January 17, 2018

# **Westside Emergency Firefighting Water System Options Analysis**

Prepared for the San Francisco Public  
Utilities Commission

January 5, 2018

Figure 1 Existing AWSS (ESER 2010 AND 2014 improvement omitted), FRAs (red numbers and boundaries) and cisterns (blue circles)

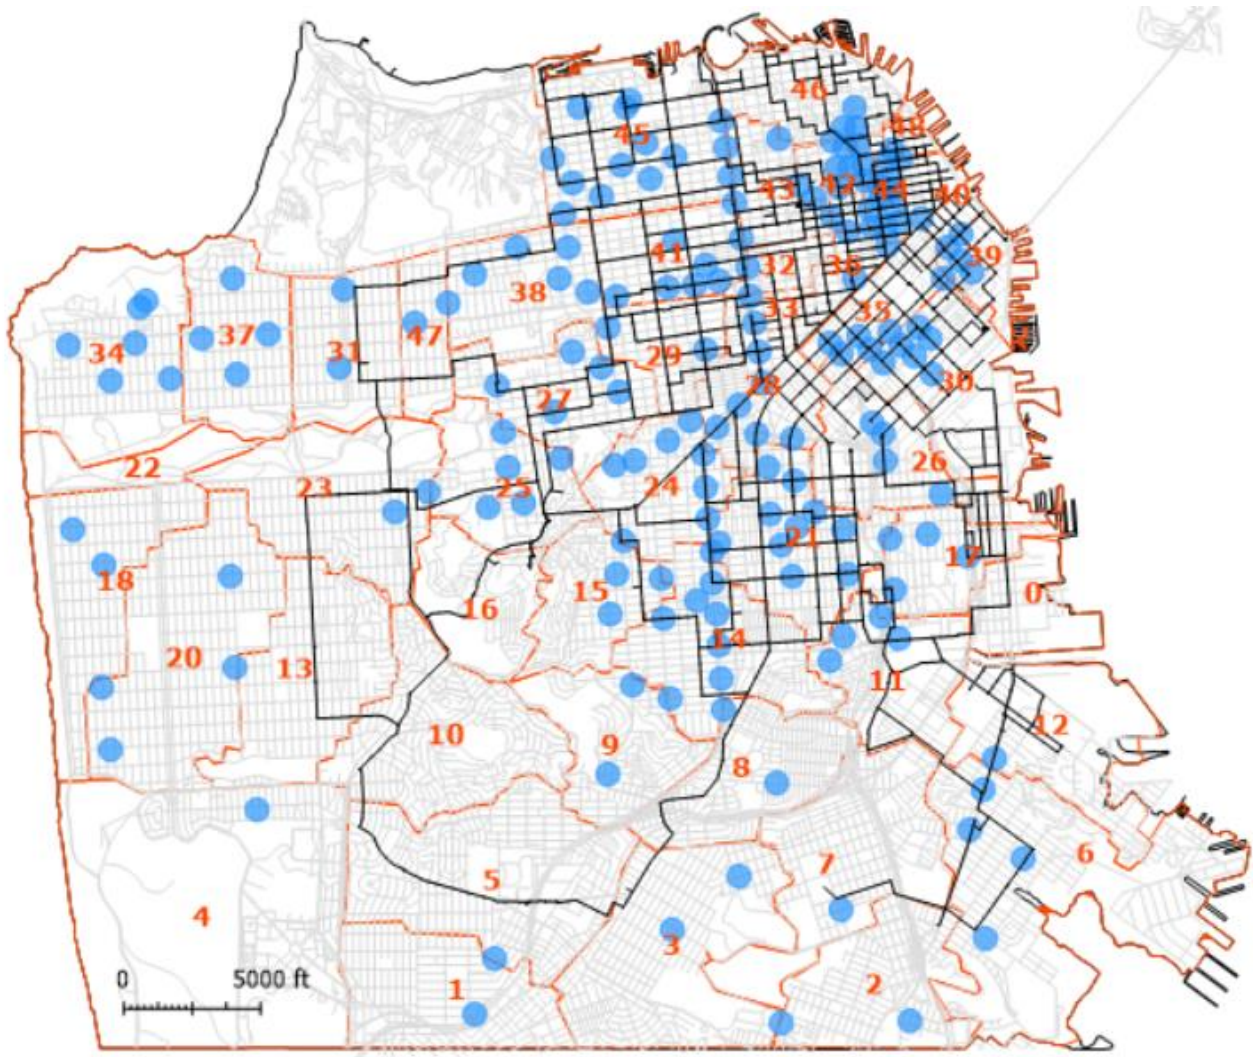
- ii. The design of the AWSS is rather unique (see Figure 1) – it seeks high post-earthquake reliability via multiple sources of supply (Twin Peaks, two salt-water pump stations and fireboat manifolds), a gridded network and other features. The high pressure supply reduces the need for fire engines and permits a continuous water curtain to be sprayed from a line of high pressure hydrants along a defensive line, without fire engines. The AWSS buried piping network was designed from the beginning to be highly earthquake resistant with extra heavy walled pipe and restrained joints at numerous points. Because San Francisco has areas of highly liquefiable soils, the system is designed to quickly isolate these “infirm zones” so that the rest of the system isn’t drained. In the 1980s gate valves isolating the infirm zones were motorized so as to be seismically actuated and also remotely controllable via radio. Further backing up the AWSS are 182 cisterns, each typically providing a one hour supply for a fire engine. Designed over a century ago with great foresight and skill, the AWSS is a seismically reliable water supply system for catastrophic fire protection. In summary, the AWSS achieves high reliability by having multiple sources, a highly redundant network and special piping and valves. Additions and expansion of the EFWS should seek to provide comparable reliability, using today’s best available technology.

Figure 2 AWSS Program Alternative B as presented in CS-199 (AECOM/AGS JV, 2014)

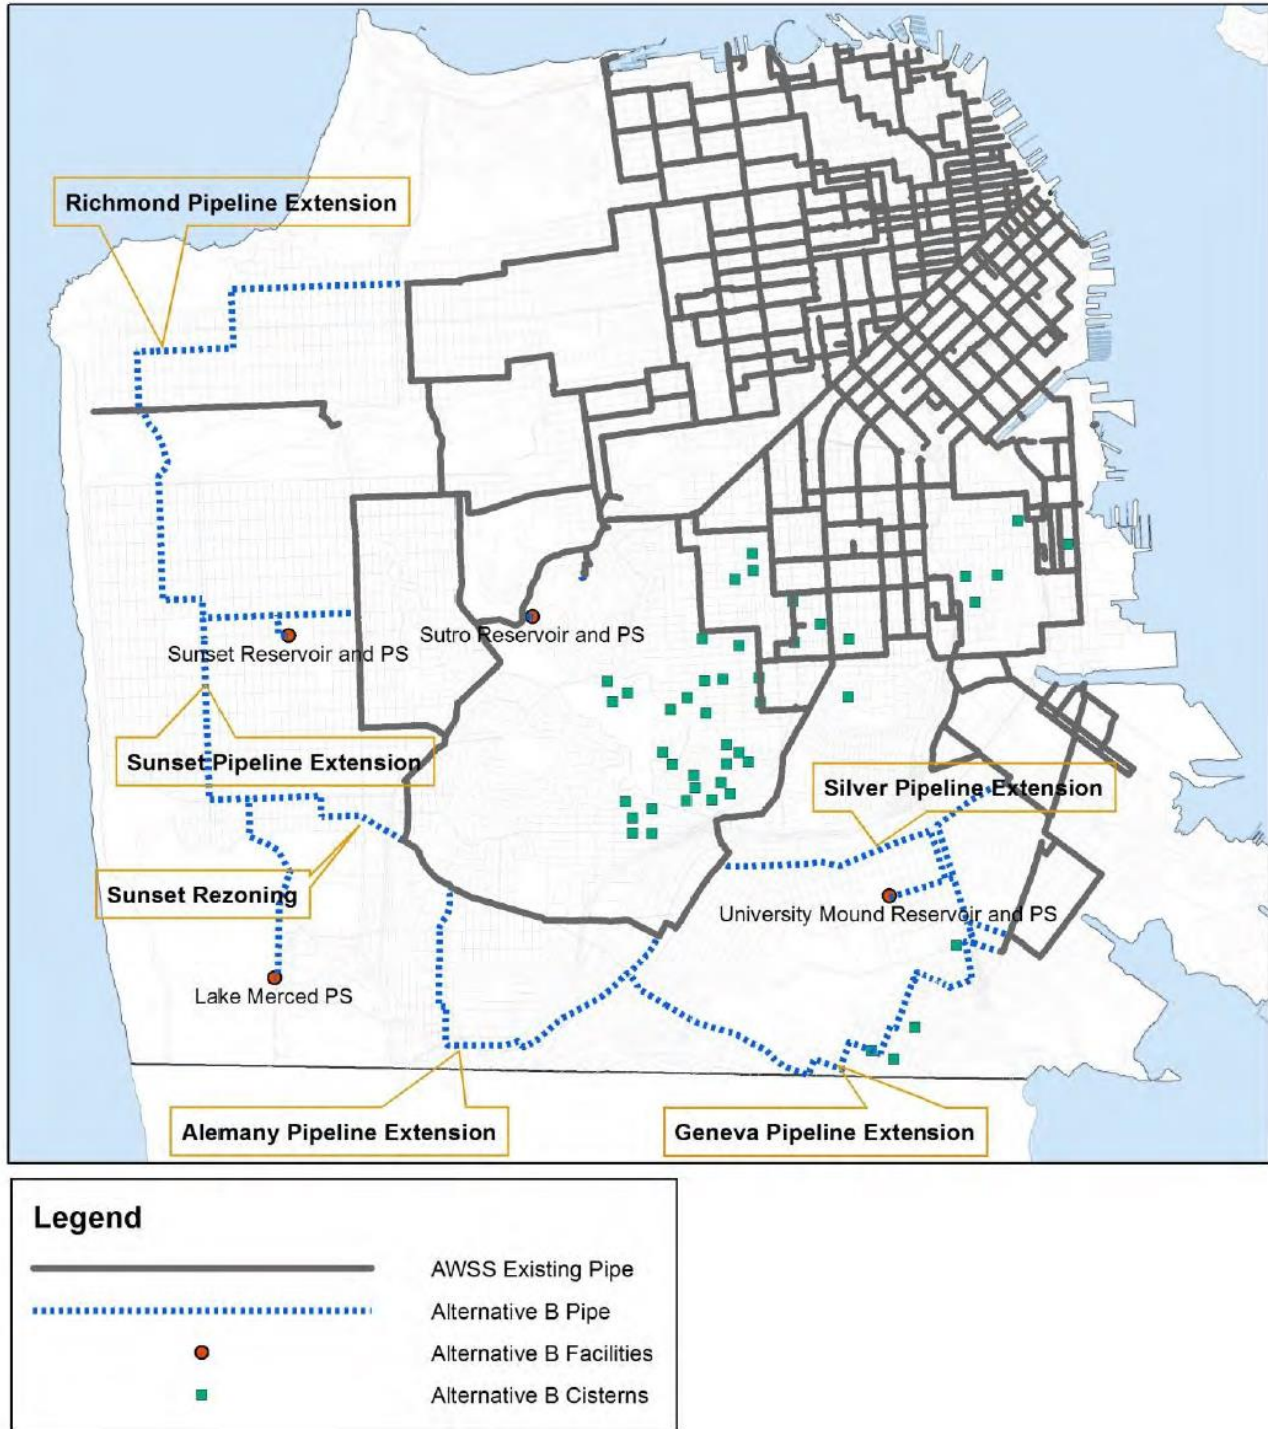
The AWSS as originally built covered virtually all of then-built San Francisco. Since then, the city’s outlying neighborhoods, such as the Richmond and Sunset Districts, have been almost entirely built out, still largely of flammable wood frame construction. In recognition of this situation a set of future projects were identified in the CS-199 report (AECOM/AGS JV, 2014), Figure 2, of which the current report addresses one:

That is, this report and its analysis of options for the Richmond District is only one of dozens of projects being implemented, within the context shown in Figure 2. The Richmond District is addressed because “The Richmond District EFWS ... supplies do not meet the Level of Service (LOS) goals”, which are that the AWSS shall:

Figure 3 Options considered in the report (after AECOM, 2018)

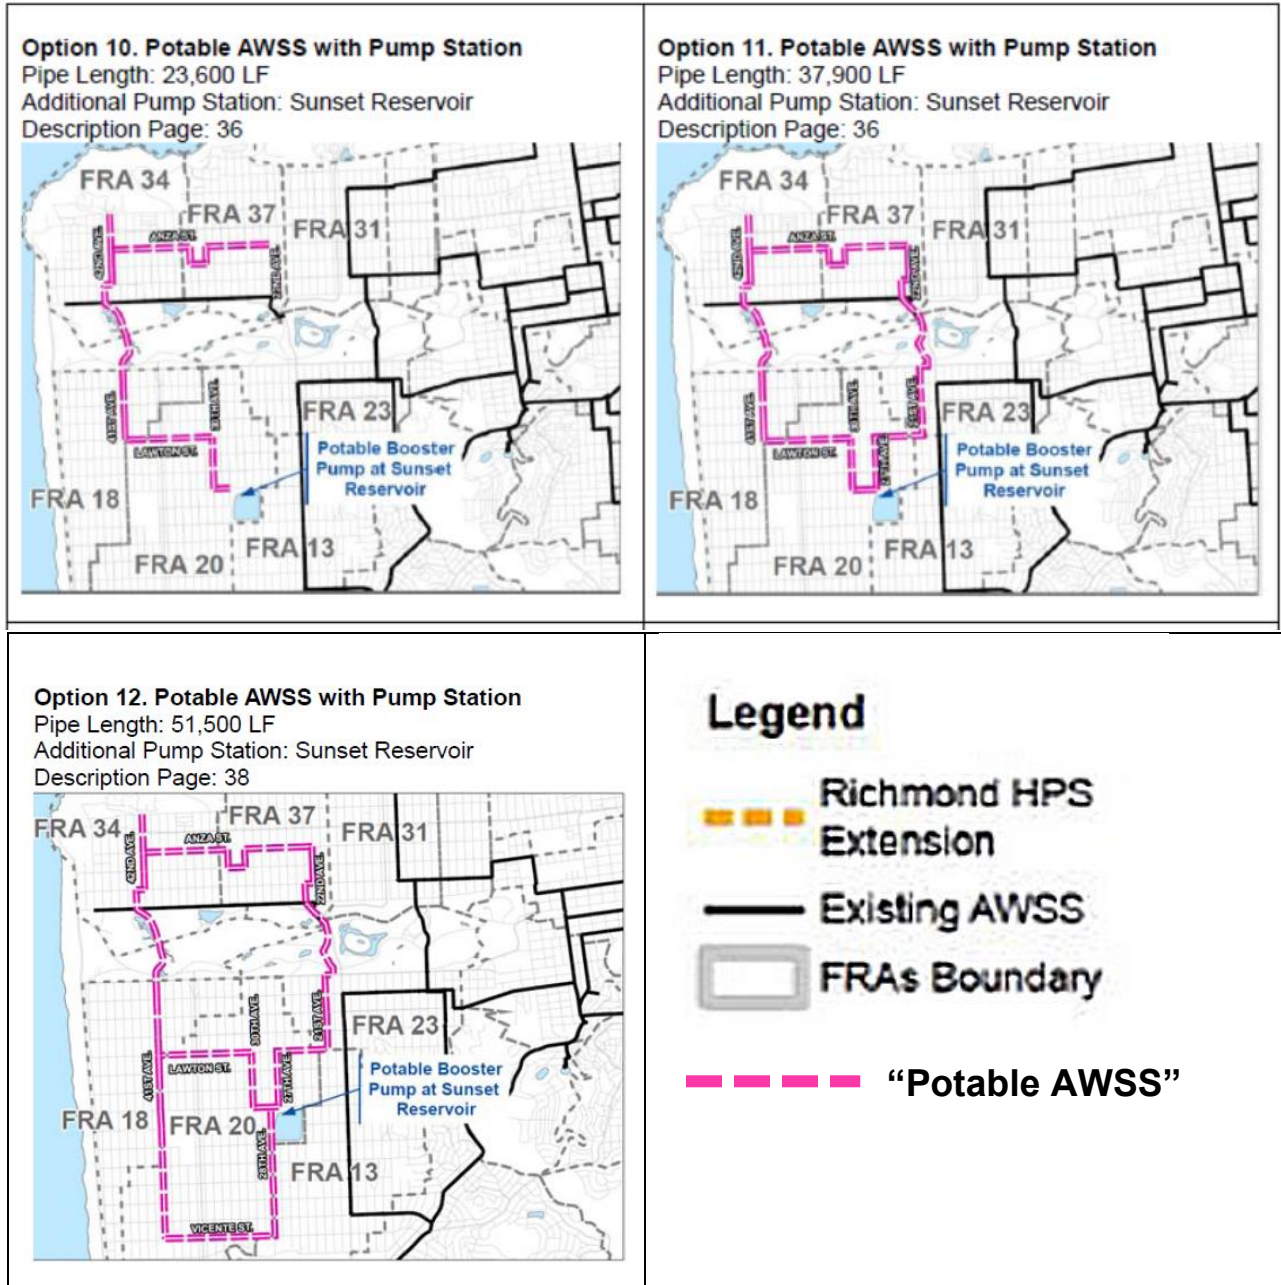
- (1) **Extensions of the existing AWSS** further into the Richmond District are considered in a “Base Case” and five options, all of which consist of a new pipe loop from the existing AWSS westward to cover the entire Richmond (see Figure 3), with some options also connecting across Golden Gate Park to the existing AWSS loop there. Of these six cases, only Option 4 and 5 meet LOS goals. Simply put, the existing AWSS is strained to supply water from its sources all the way to the Outer Richmond – judicious piping arrangements in options 4 and 5 manage to achieve this but the existing system is reaching its limits. These options add no new sources, but are supplied from the multi-sourced redundant existing AWSS, and the new Richmond extension is a looped network.

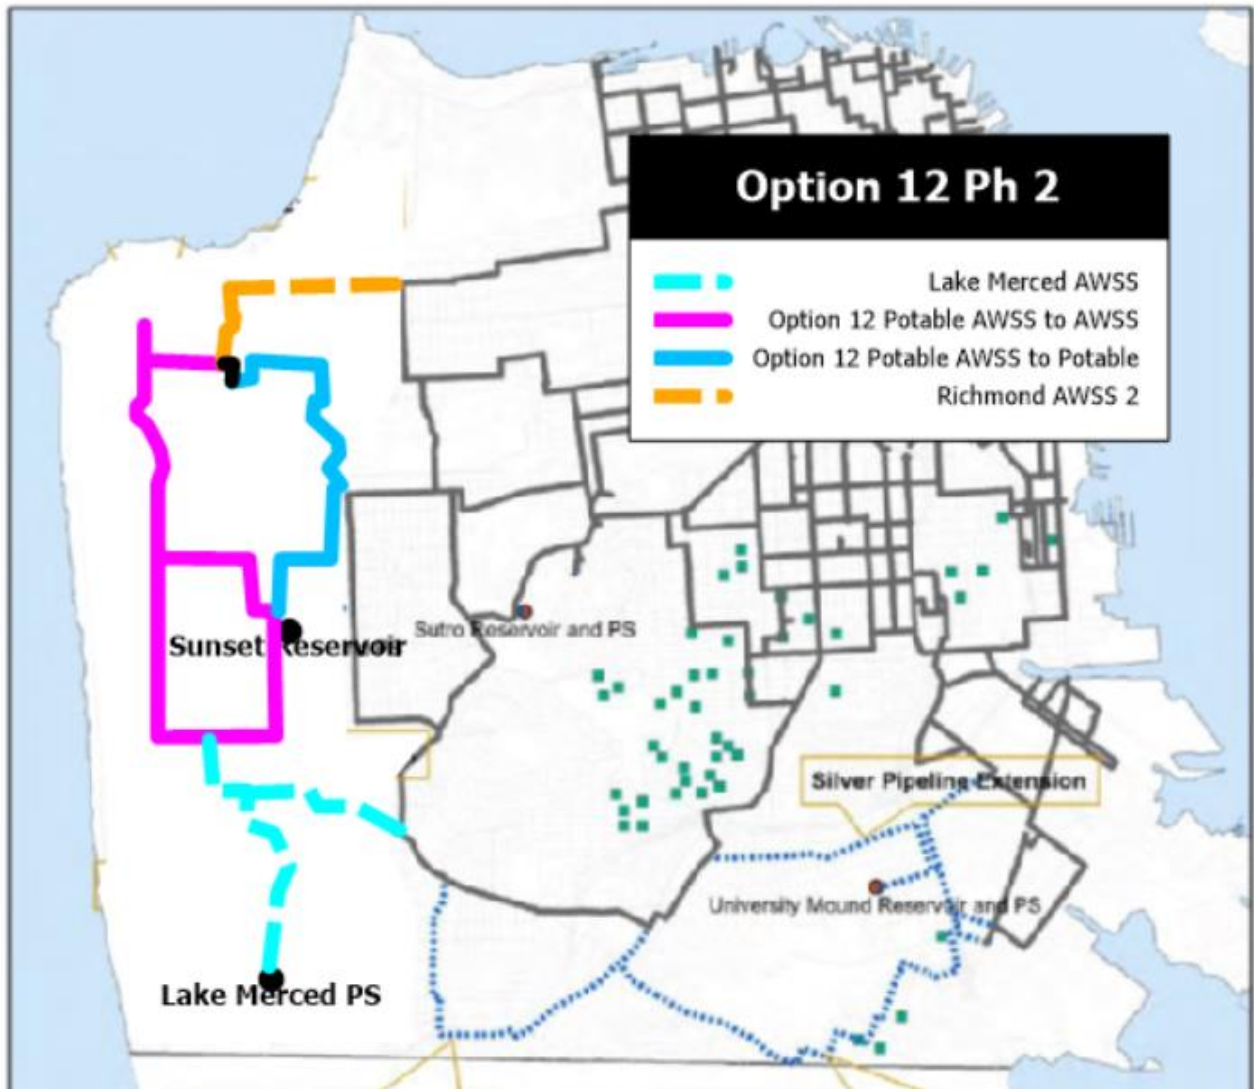
However, if the longer view is taken, then option 12 can be regarded as the first phase of a longer term buildout of the AWSS in the western portion of San Francisco. Figure 4 shows how this might be accomplished – option 12 as a Potable AWSS is built first, and provides EFWS to the Richmond and Sunset Districts, as well as improved potable water supply and

Figure 5 Fire flow demands used in the report (identical to Figure 2 of AECOM, 2018). The demands are median values and sum to 89,529 gpm.

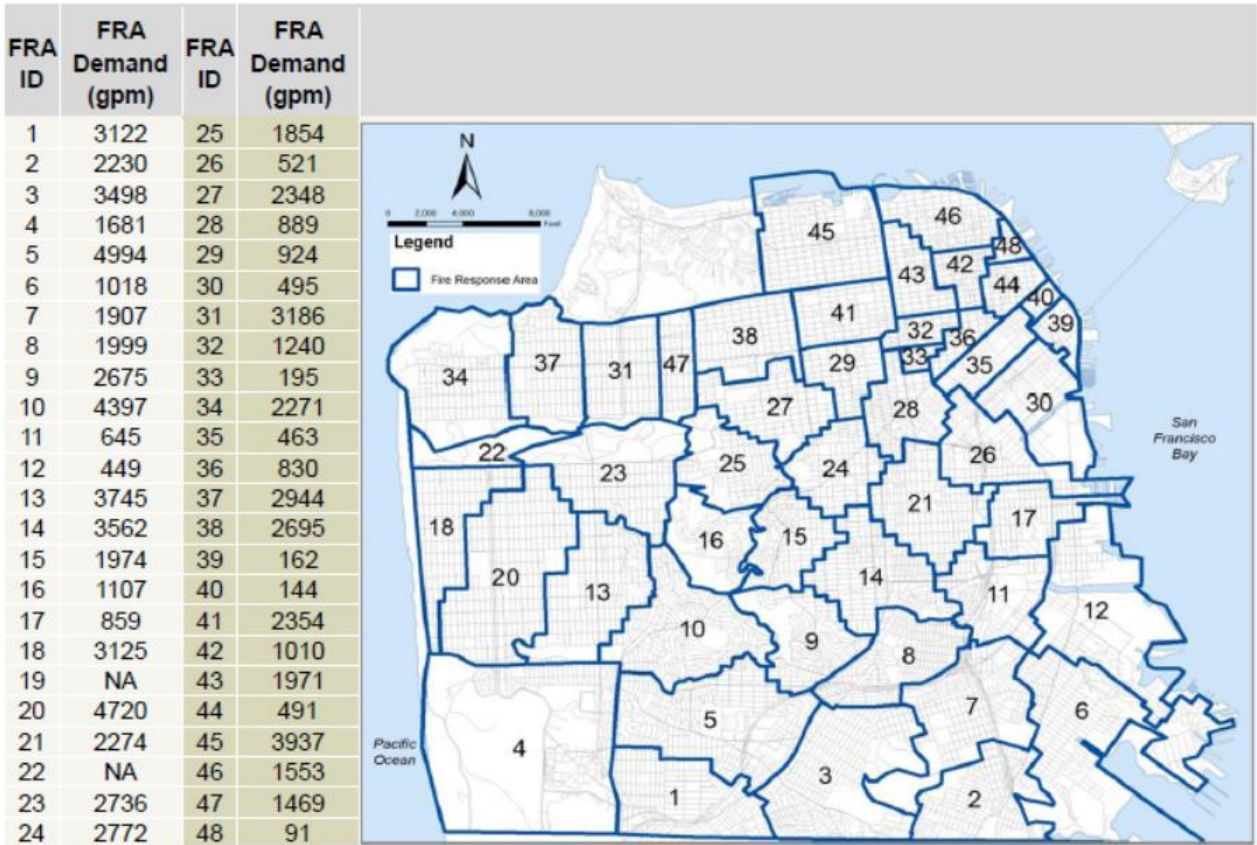
The report’s flow demands are shown in Figure 5 and are based on results of a fire demand analysis performed for CS-199 – the results were 1,000 simulations of minute-by-minute estimates of fire flow demands required at each block in the city, which are summarized in Figure 6. The median flow required at the end of 60 minutes was 113,589 gpm with a standard deviation of 58,597 gpm. Because these were based on no Fire Department intervention, the CS-199 in consultation with the Fire Department reduced the flow requirements to account for some fires be quickly suppressed, resulting in median estimates shown in Figure 5, which sum to 89,526<sup>1</sup> gpm. These required fire flow values were used in CS-199 and the current report. In summary, there is considerable variation in fire size and water demands, but the report is based solely on median estimates.
